Request for Class II Permissive Change(C2PC)

FCC ID: VG8EM025FXX-Y

Data: 2020-8-30

1. Changed Mother -board as below.

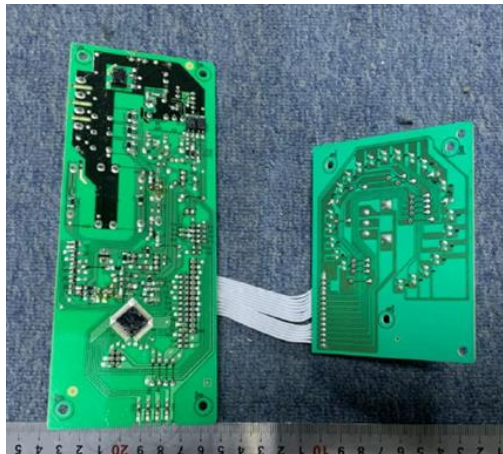
The original top /Bottom view (EM Series)

The new top /Bottom view(AM Series)

- The new mother board is a switching power supply instead of the original linear transformer scheme. They have the same input, output and power except for PCB layout and some electronic component differences.
 - “AM” and “EM” only are controller type differences, They all belong to the same family of products
2. The model of High-voltage transformer is changed from MD-101AMR-1 to MD-101AMR-3.
 3. Everything else is the same as before.
